SUBSURFACE WASTEWATER DISPOSAL SYSTEM APPLICATION

Subject: New System Variance approval, Slade property, Leavitt Street,
Augusta

Subject: Variance to the Maine Subsurface Wastewater Disposal Rules, Slade property, Leavitt Street, Augusta

Subject: Frank R. Slade Property,
Leavitt Road, Augusta, ME

SUBSURFACE WASTEWATER DISPOSAL PLAN

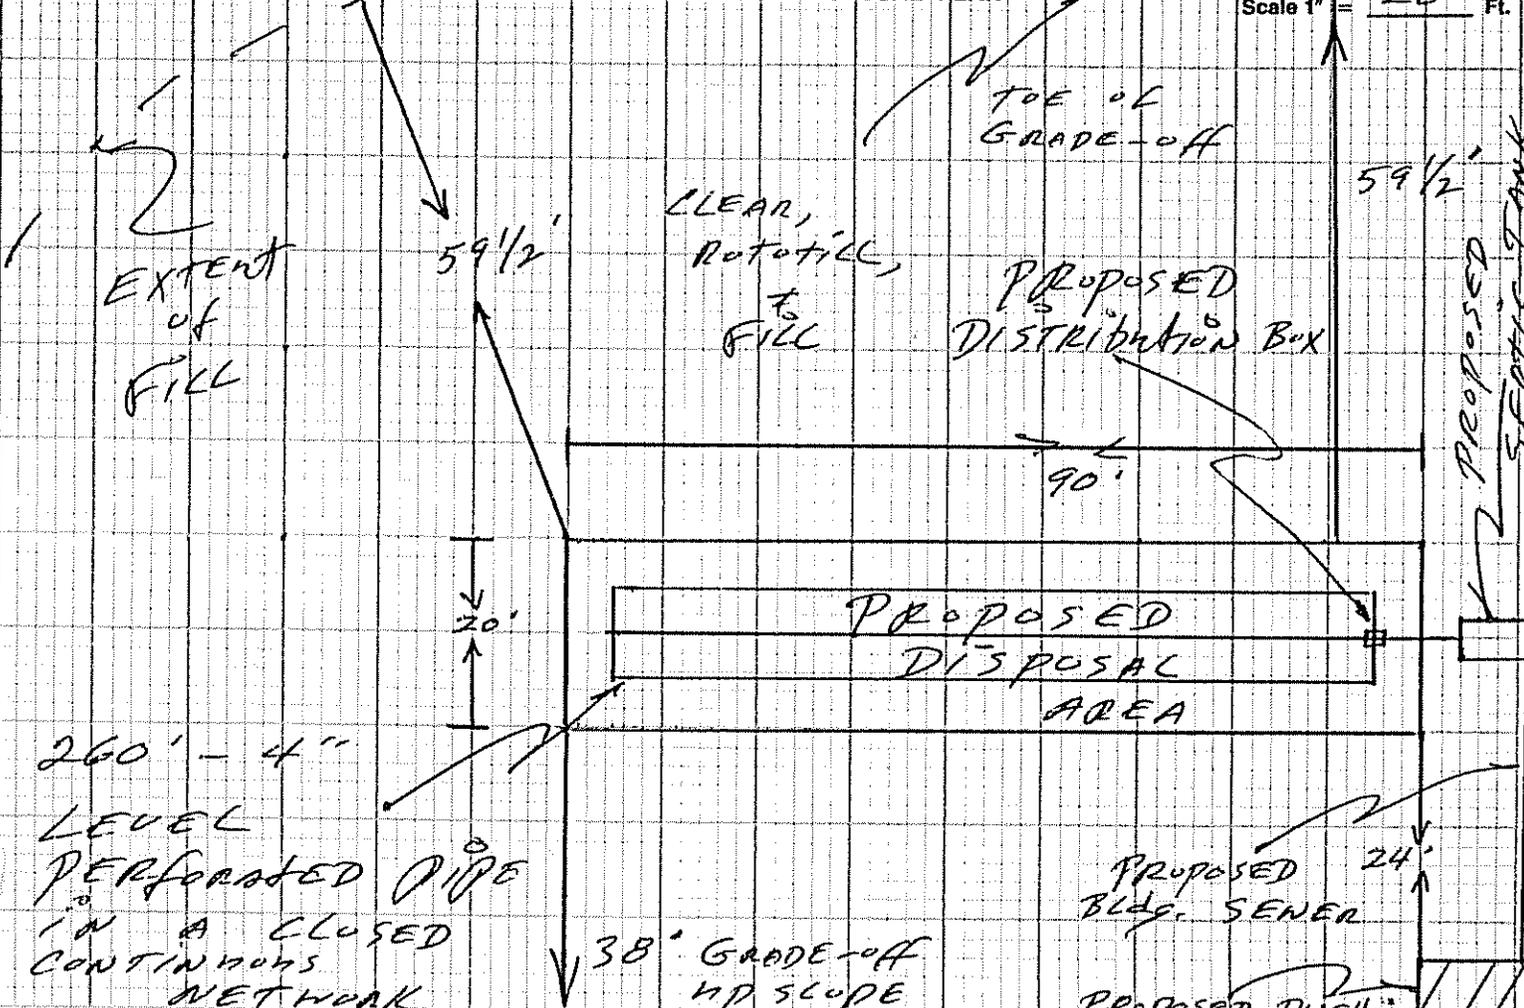
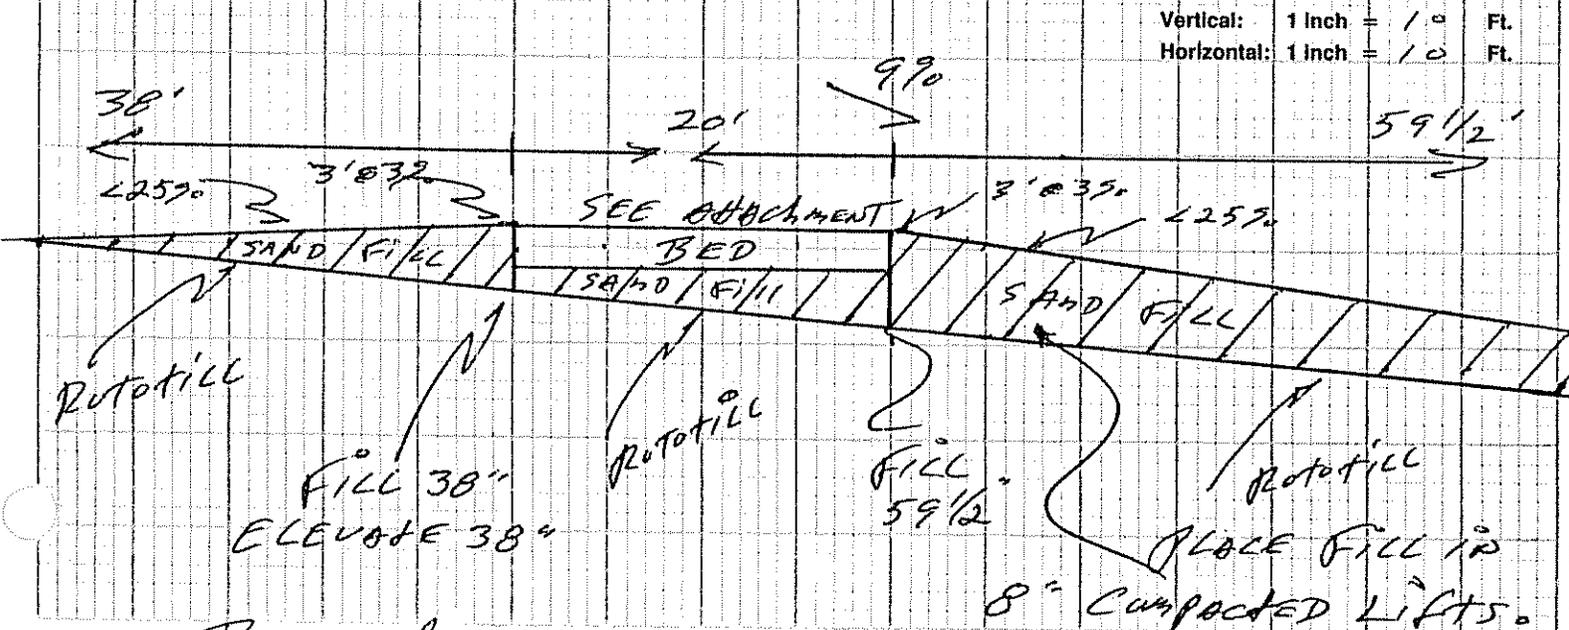
THE SOIL IS UNDERLAIN BY DENSE CLAY - TYPICAL OF THE AUSTIN AREA - HAS A SEASONAL PERCHED WATER TABLE AT 10" FROM SURFACE - LOT IS 12 1/2 AC. - SYSTEM OVERDESIGNED BOTH IN SIZE & FILL FACTORS. POTENTIAL FOR VARIANCE APPROVAL IS MARGINAL.

The Division approves of the application dated March 29, 1987 by Bruce A. Whitney, SE.

SUBSURFACE WASTEWATER DISPOSAL PLAN

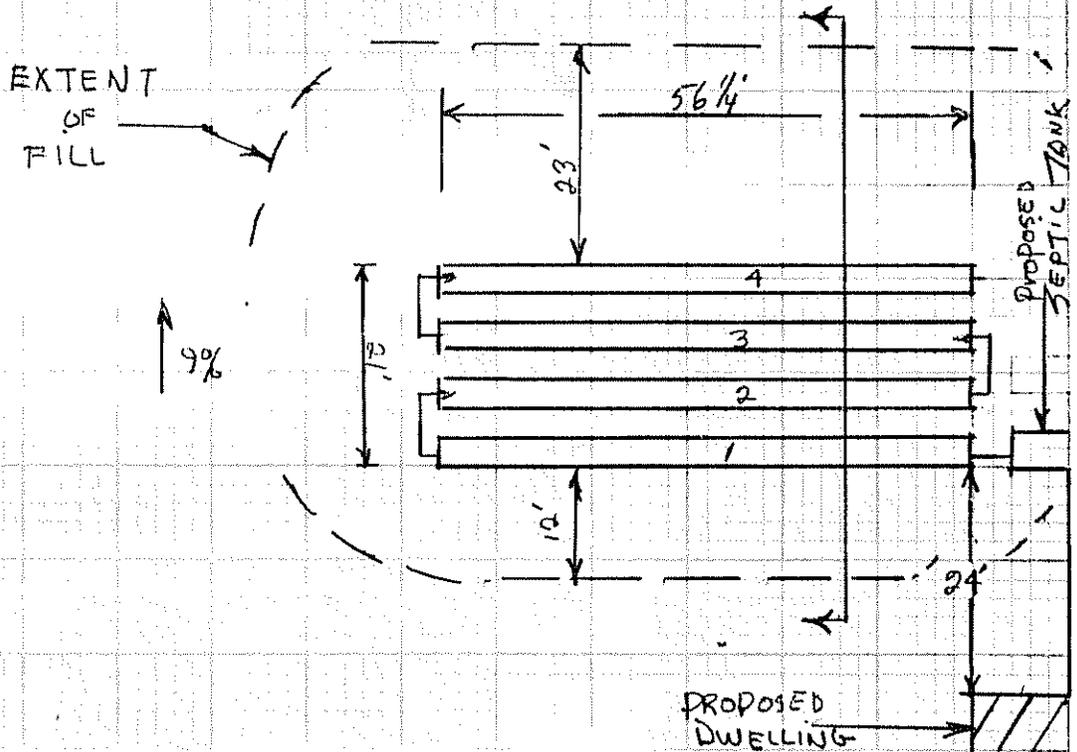
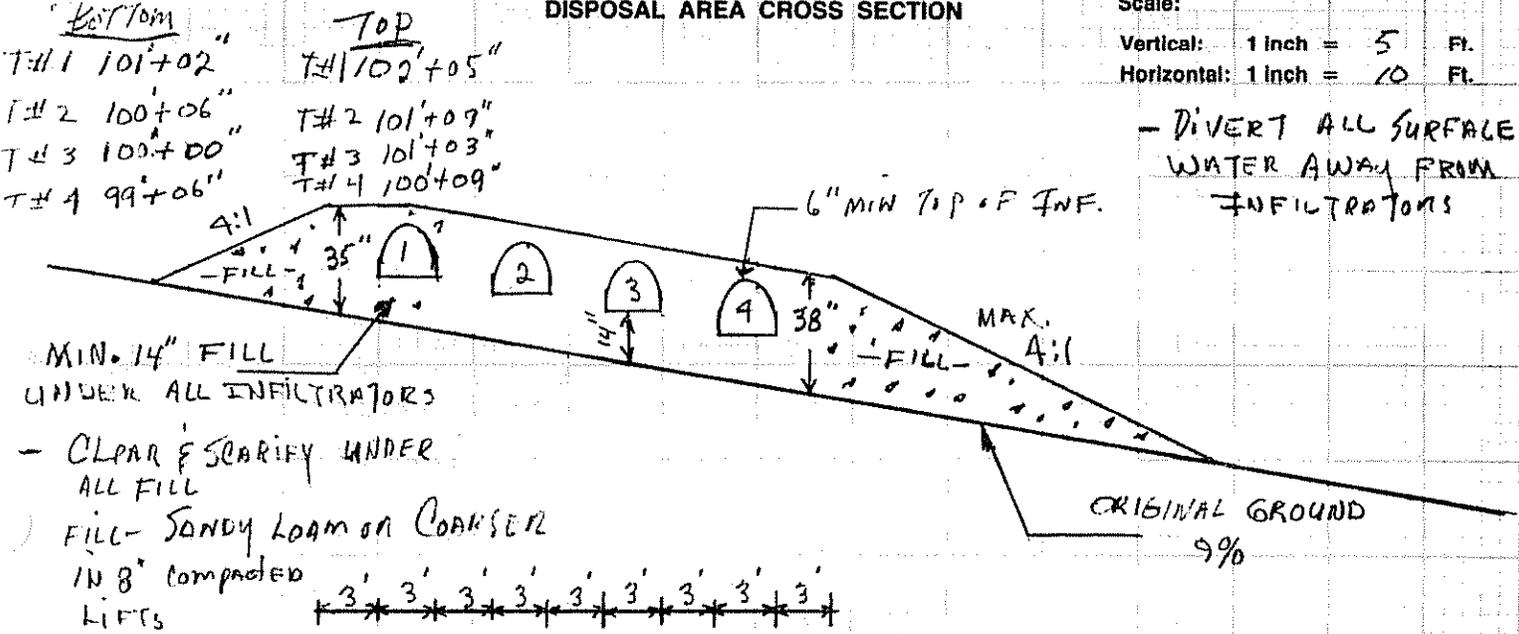
Mr. George Soucy, Jr.-Local Plumbing Inspector and I met with the owner, MR. Frank R. Slade at the property yesterday at the request of Steve Allen. Our inspection showed that at the very western end of the system the following amounts of fill were placed between the bottom of the Infiltrators and the original ground: Row 1-14", Row 2-13", Row 3-12", Row 4-10". However, at the eastern end of the system all rows had more than 30" of fill under the Infiltrators.. The design called for 14" of fill. It also appeared that under the very eastern end of the system that some of the original ground had not been scarified. Mr. Slade stated that he did observe the grass and organic layer being removed under the system. Mr. Soucy and I both explained to Mr. Slade how critical the scarification is to a properly functioning system. The fill extensions on the east, west and south sides had not been placed nor had they been scarified.

Health Engineering's approval letter of April 30, 1987 stated that Mr. Whitney shall be retained to establish the system location and elevation. Although this was not done and the elevation reference point had been knocked down during the construction of the building, other than the afore mentioned difference in fill the grades and location are as proposed. In view of this and the fact that overall there is substantially more fill under the system than the plan required and there is a minimum 20" separation distance from the bottom of the system to the seasonal High Water table (12" required by code), I recommend this system be approved with the following conditions:

- 1) The area under the fill extensions be rototilled before the fill is placed.
- 2) The joints between the Infiltrators be checked before backfilling and hay or appropriate material be used to cover the small holes in the overlap where necessary.

- 3) Mr. Slade accepts the responsibility that the topsoil was properly removed and scarified under the system.
